Subject: **ACTIVE TRANSPORTATION PROGRAM – PROJECT SCOPE
AMENDMENT – FORT ORD REGIONAL TRAIL AND GREENWAY: CALIFORNIA
AVENUE SEGMENT PROJECT
RESOLUTION ATP-P-2425-13**

PROJECT NAME: Fort Ord Regional Trail and Greenway: California Avenue Segment

This document serves as supplemental information to the Exhibit 25-D REQUEST FOR PROJECT SCOPE CHANGE (attached) completed by Transportation Agency for Monterey County (TAMC) and submitted to Caltrans on 1-30-25.

Date: 10/17/2024
PPNO: 3130A
Federal PROJECT #: 6143(101)
ATP ID #: 0523000102

Original plans with changes highlighted

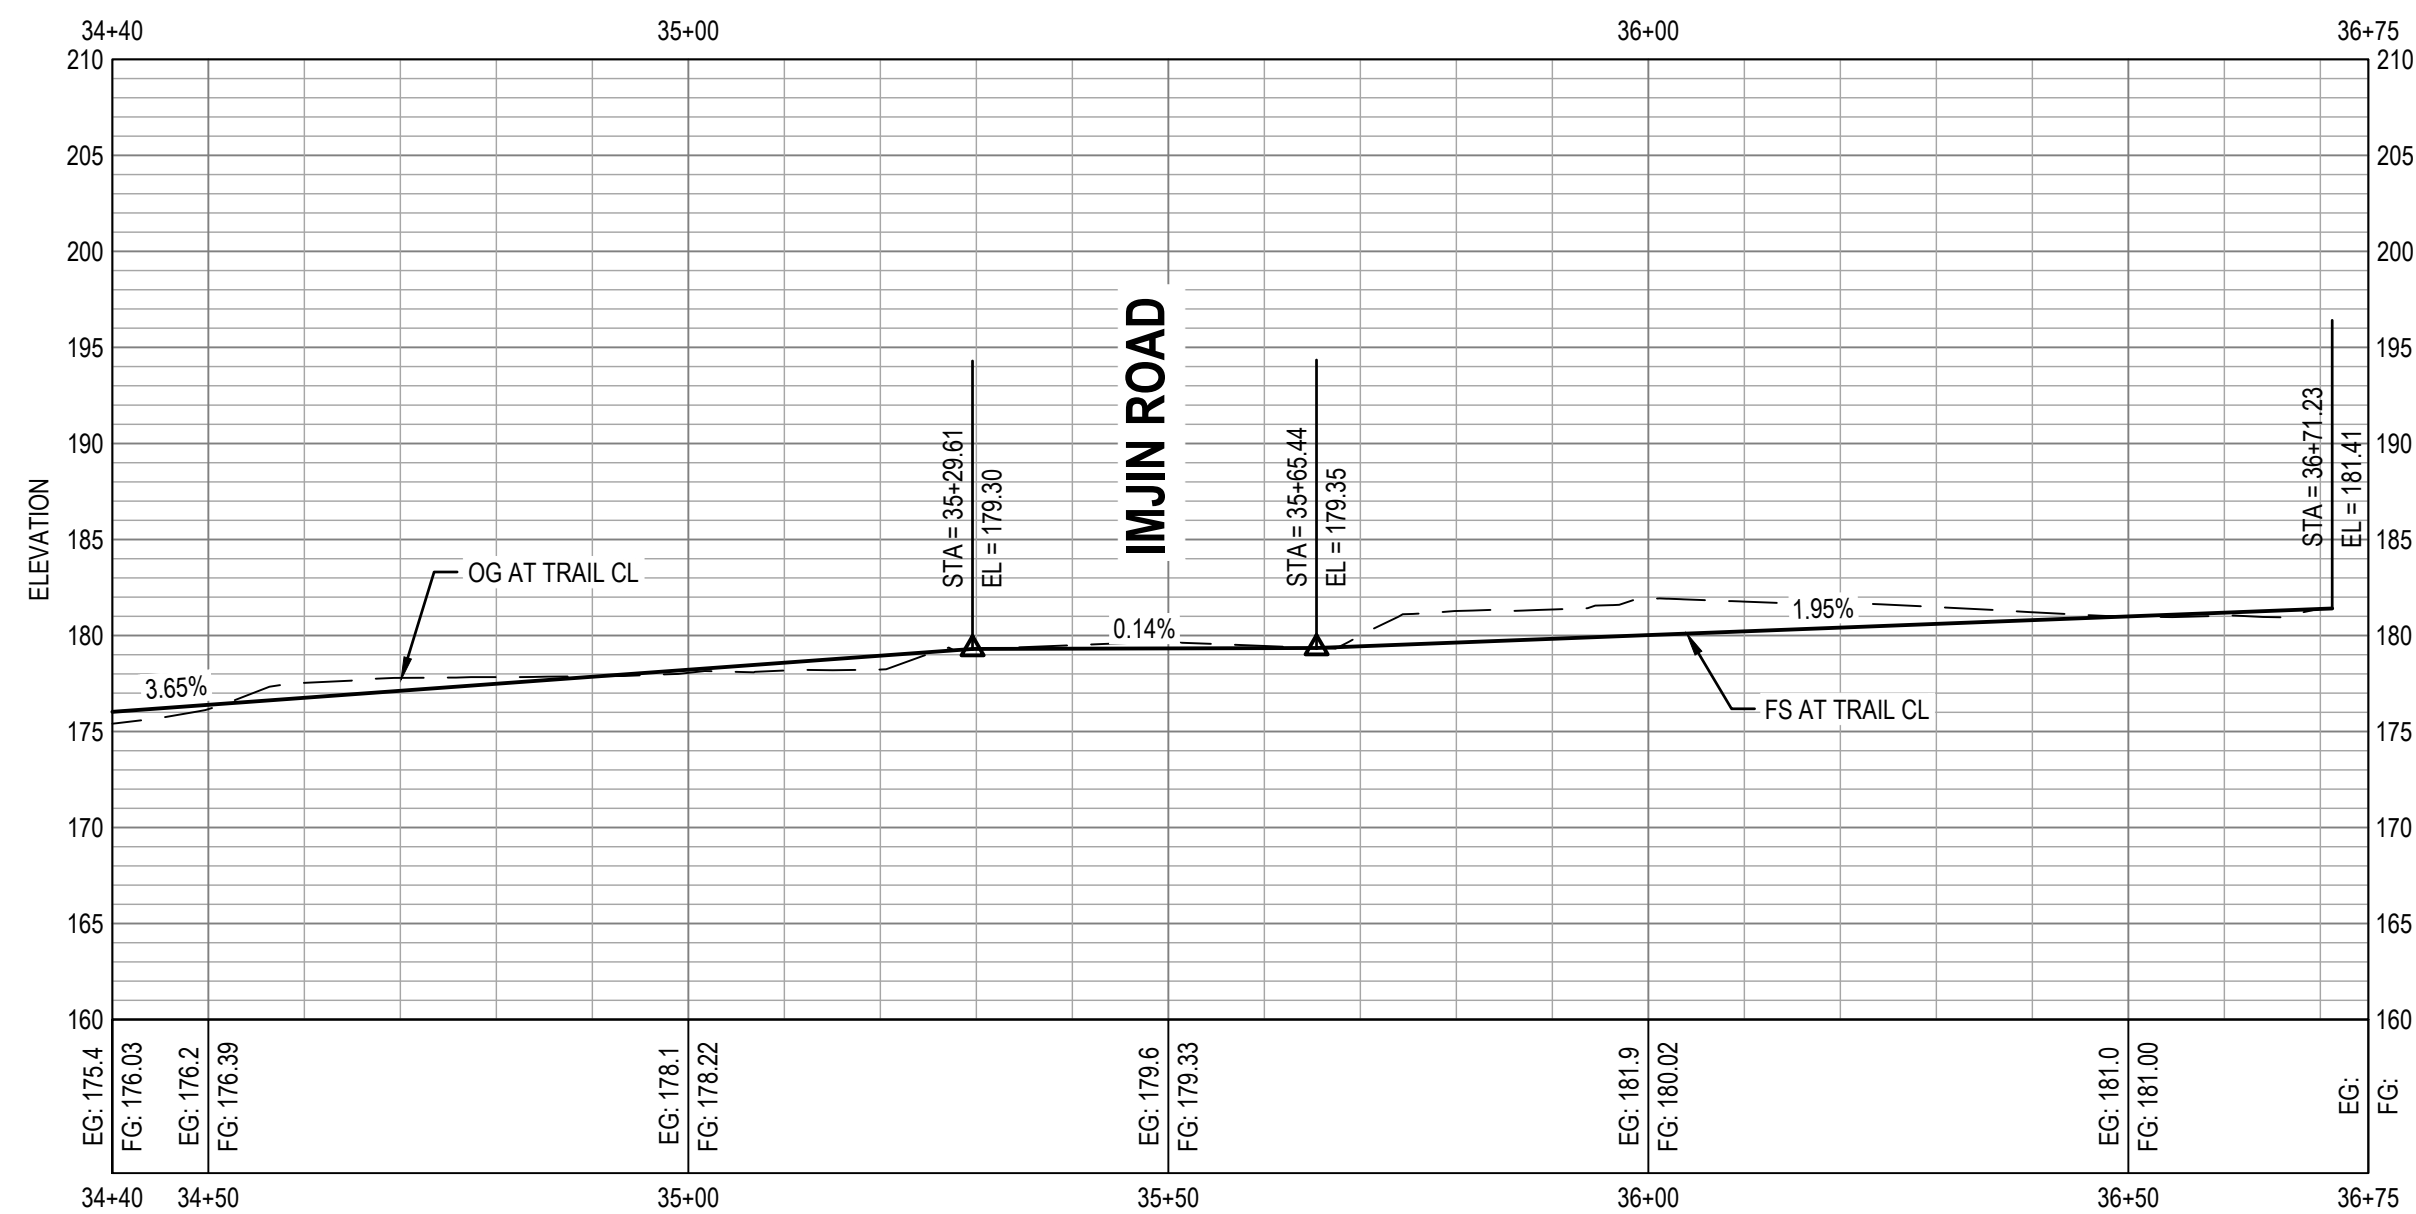
The proposed scope change is to move from a pedestrian bridge over Imjin Road to an at-grade crossing at Imjin Road. In the ATP application, the pedestrian bridge was planned to be located at Imjin Road as per the Draft 30% FORTAG CSUMB North Loop Extension plans prepared by Alta, dated 04/13/2020. The bridge crossing will be replaced by a mid-block at grade crossing along Imjin Road which will include a pedestrian signal to stop vehicle traffic on Imjin Road when activated. At the time of the ATP application the bridge was determined to be the best solution, however, since the application was submitted, geotechnical studies, topographic mapping, and environmental surveys were conducted, as further explained below, which exposed challenges to the bridge that were not known at the time. In addition, at the time of the ATP application, there were no plans for improvements on Imjin Road. The City of Marina has since moved forward with the environmental clearance and design of roadway improvements immediately adjacent to the project location, a roundabout, sidewalk, bike lanes, shared use paths, and transit stops at Imjin Rd and Imjin Parkway. The proposed midblock crosswalk would be adjacent to the new transit stop and would connect the FORTAG trail to this new pedestrian infrastructure, improving regional connectivity beyond what the bridge would have done.

Title **IMPROVEMENT PLAN AND
PROFILE - 21**

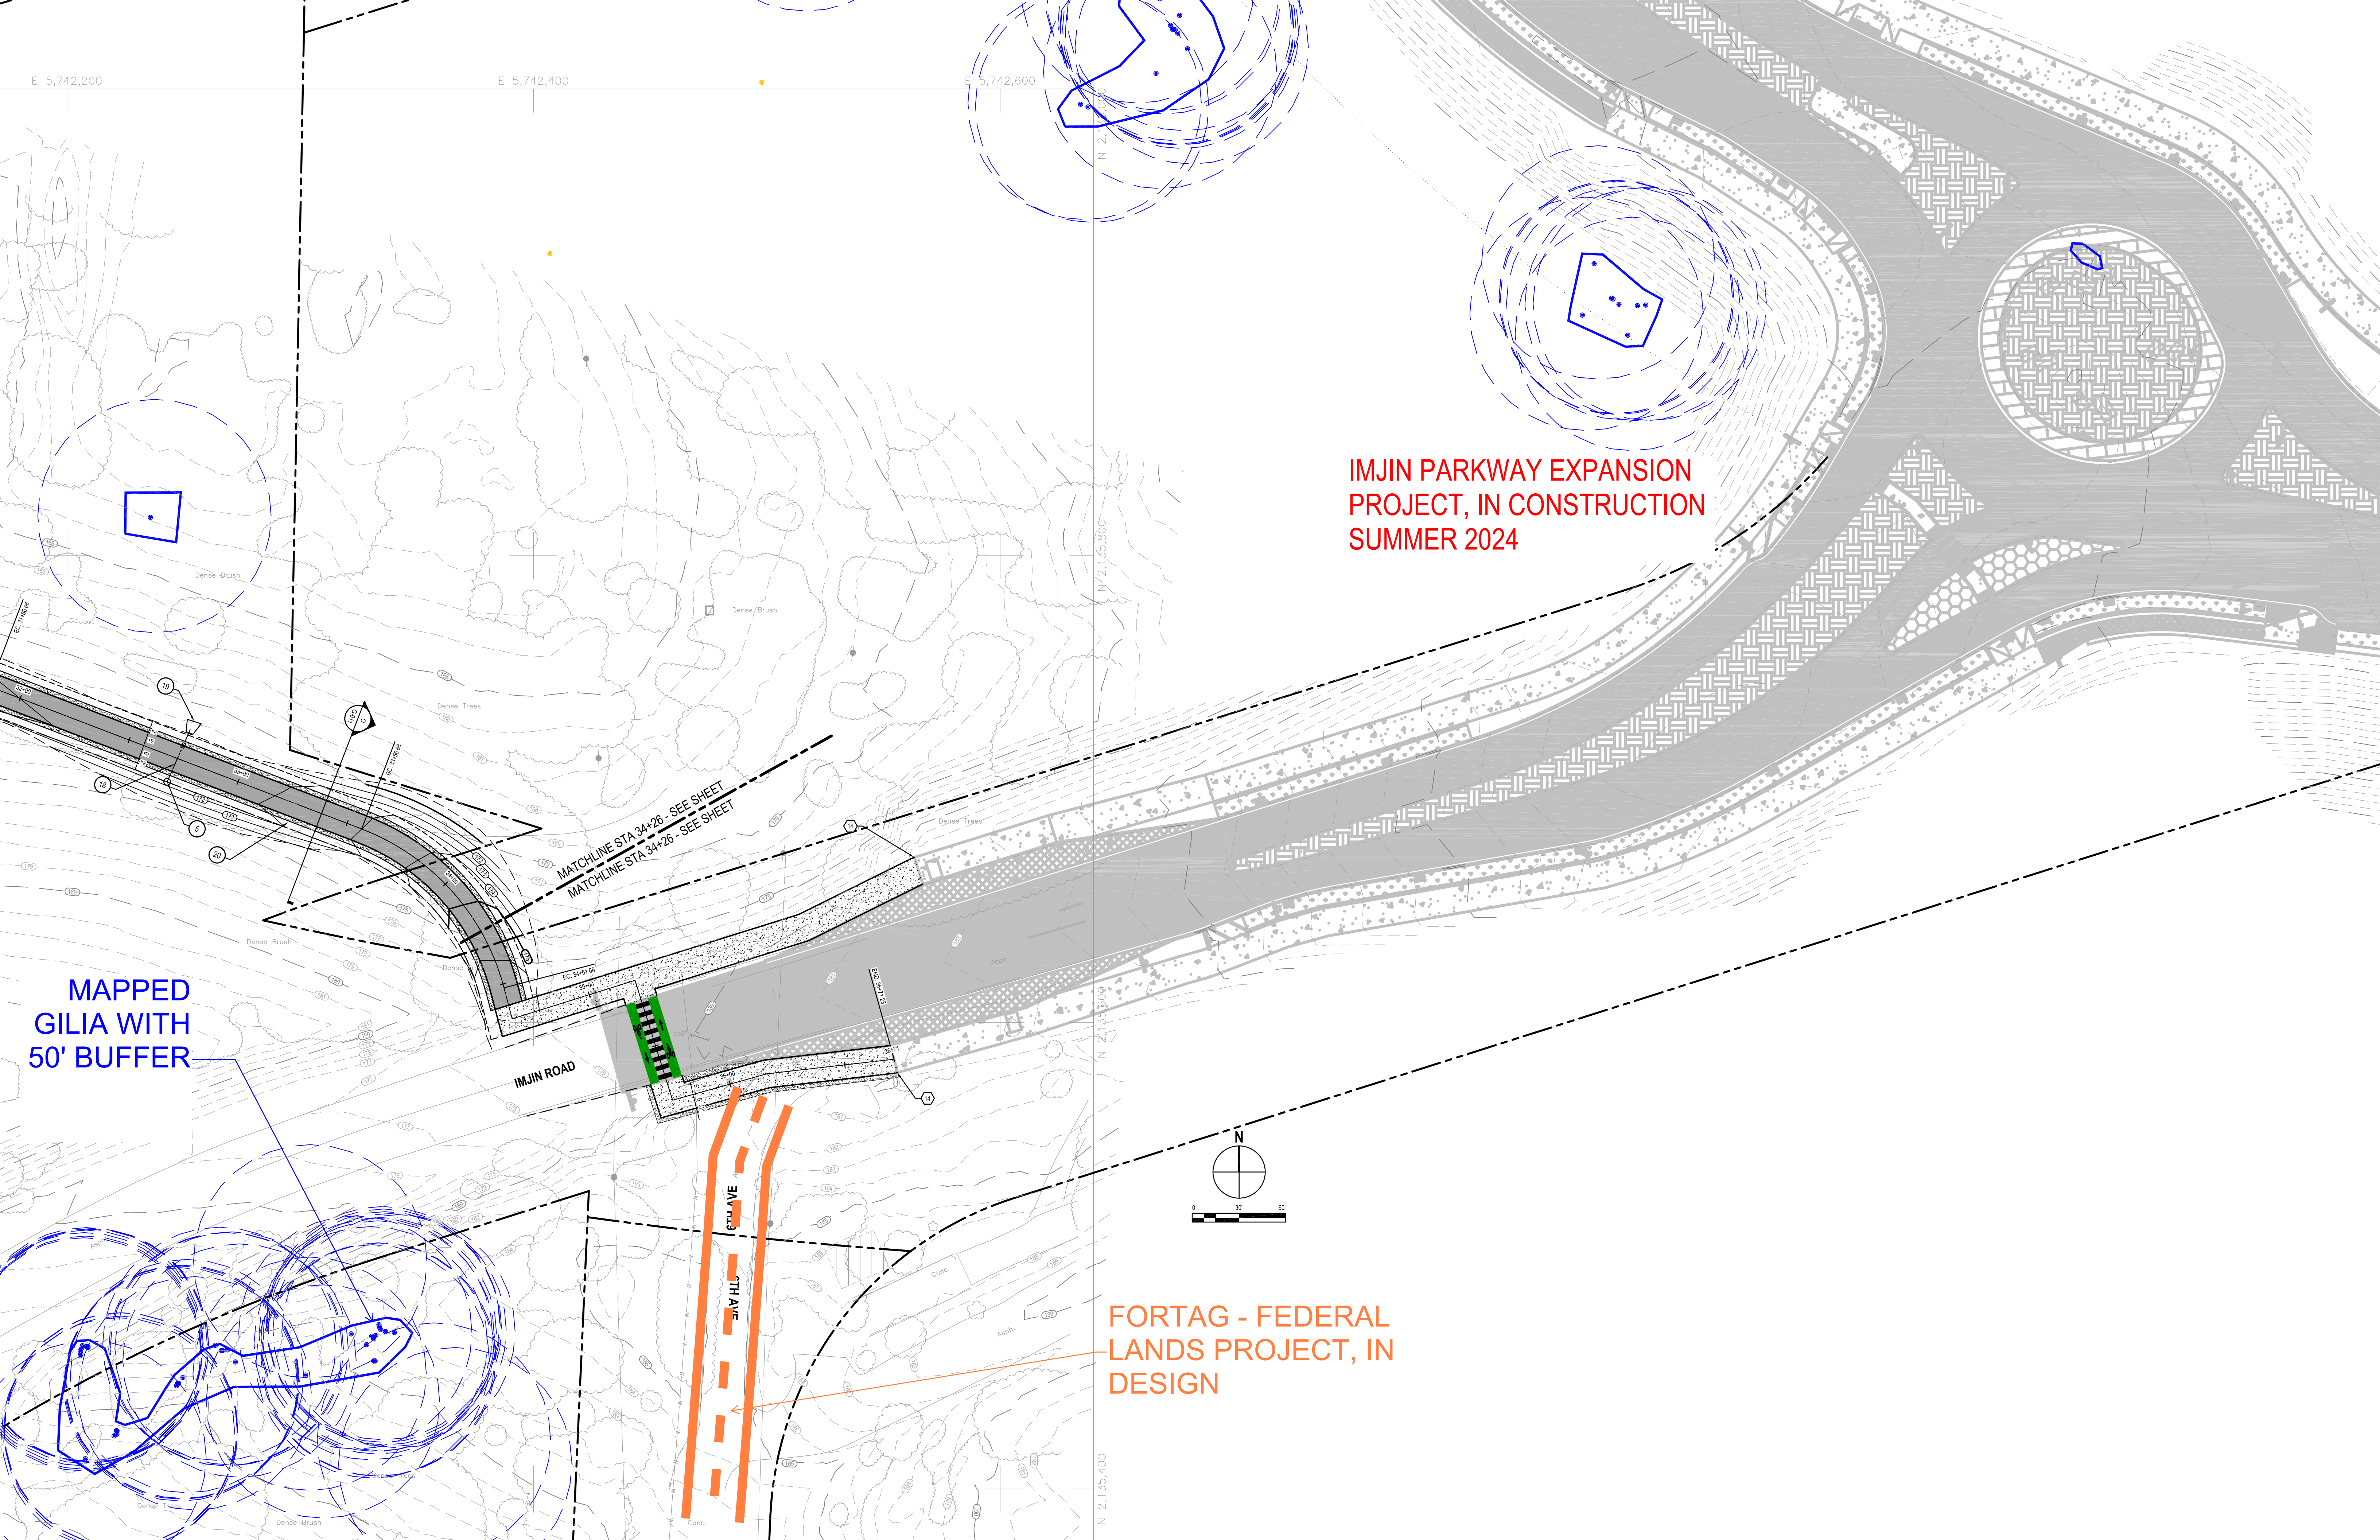
In addition to the originally scoped crossing improvements, the project now proposes two enhanced crossings on 8th Street to provide better access to CSUMB campus and enhanced crossings at California Avenue and Patton Parkway. See Appendix D for Regional Connectivity Map. See Appendix A for original plans and Appendix B for revised plans.

Proposed changes to the Project Description: Construction of a 1.8-mile segment of the planned 28-mile FORTAG, including a protected intersection and at-grade pedestrian hybrid beacon.
